# CITY OF ALBUQUERQUE

RE: **Garcia Honda Gen 3 Service Bldg**  
**8301 Lomas NE**  
**Request for Certificate of Occupancy – Permanent**  
**Hydrology Final Inspection - Disapproved**  
**Engineer's Stamp Date 8/29/18 (J19D072)**  
**Certification Dated: 4/12/18**

GARCIA  
AUTOMOTIVE  
GROUP  
GARCIA HONDA -  
GENERATION 3 - NEW  
SERVICE BUILDING

Mark	Date	Description
	05/05/17	
Project Number	15918	
Drawn By	JJB	
Checked By	VAN H. GILBERT ARCHITECT	
Copyright ©	AS-BUILT	
SHEET TITLE	GRADING, DRAINAGE & UTILITY SERVICE PLAN	
	C-101

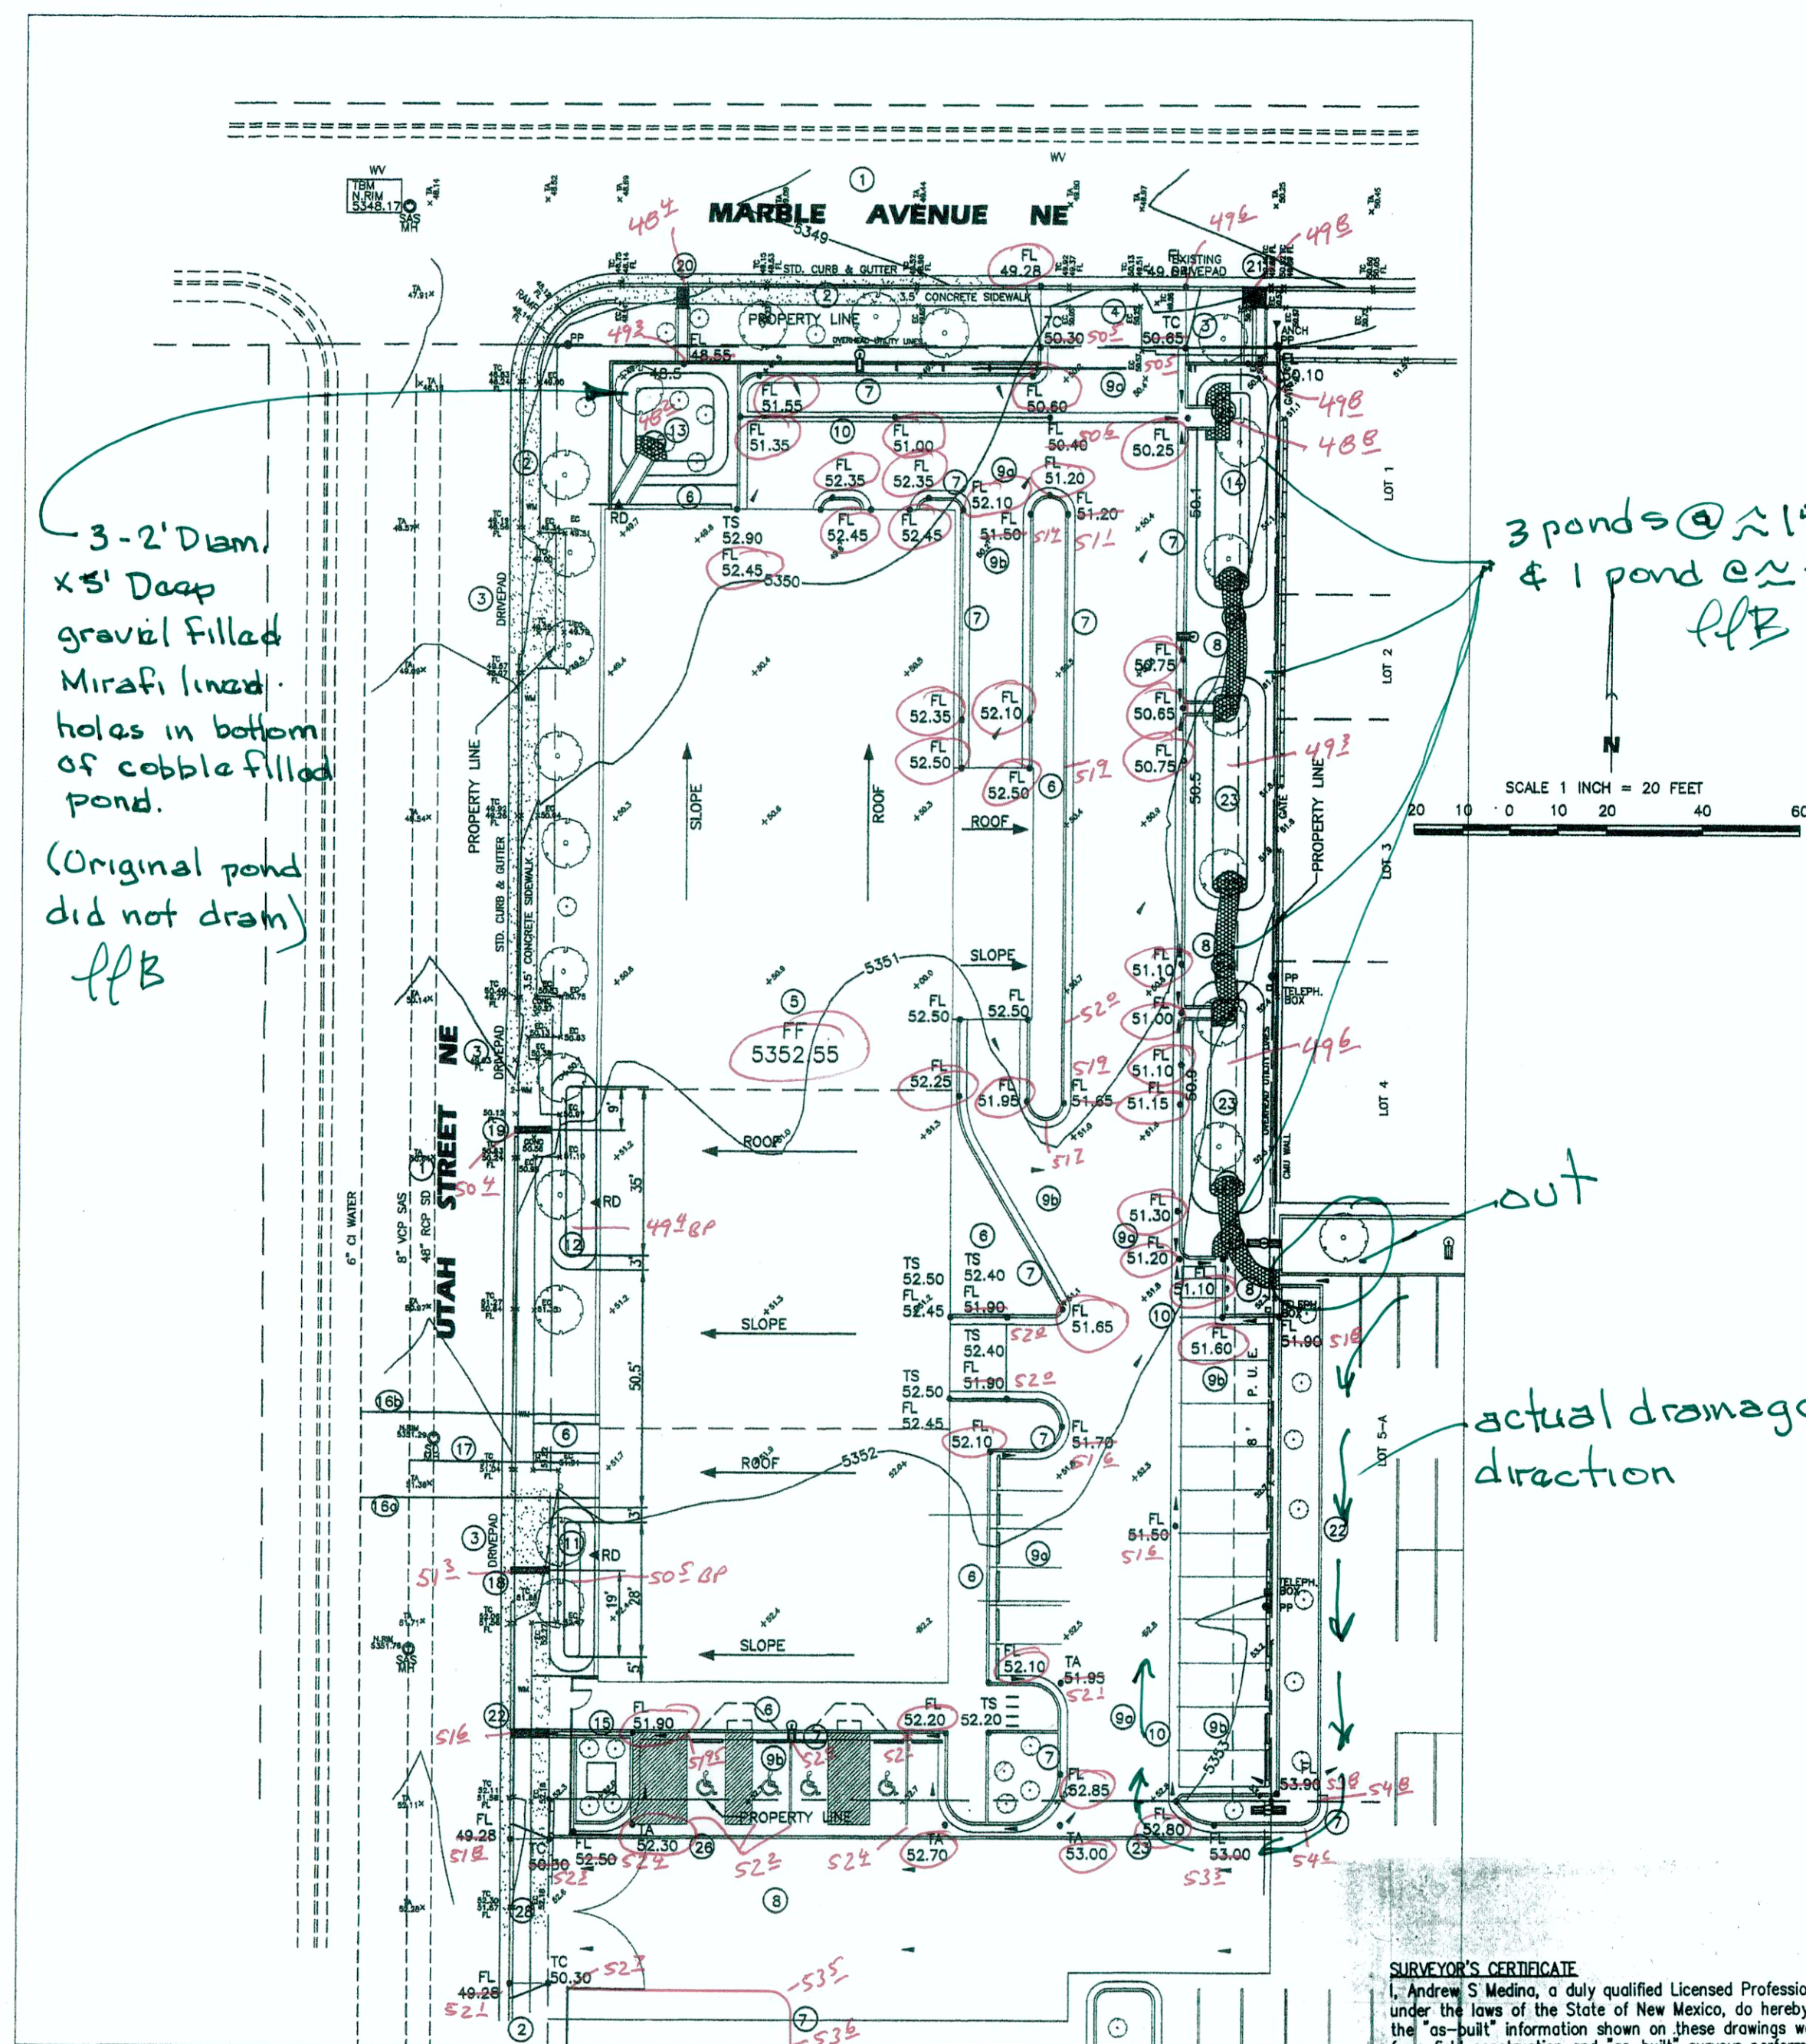
1. The Drainage Certification language, per DPM Ch. 22, Section 7, is missing.
2. The sidewalk culverts need to be built to city standards, refer to Standard Drawing 2236 for correct construction:
  - a. The smooth rod, welded to the front of the steel plat and free of burrs and sharp edges was missing from all culverts.
  - b. All screws need to be tack welded or ground down to discourage removal and theft.
  - c. The sidewalk culvert described in keyed note 19 has several screws that were not countersunk and are left projecting above the plate.
  - d. The sidewalk culvert described in keyed note 20 is not flush with the sidewalk, creating a trip hazard.
  - e. The sidewalk described by keyed note 21, needs to be removed and rebuilt as two culverts as stated in the approved grading plan. Per drawing 2236, single culverts shall not exceed 24" wide.
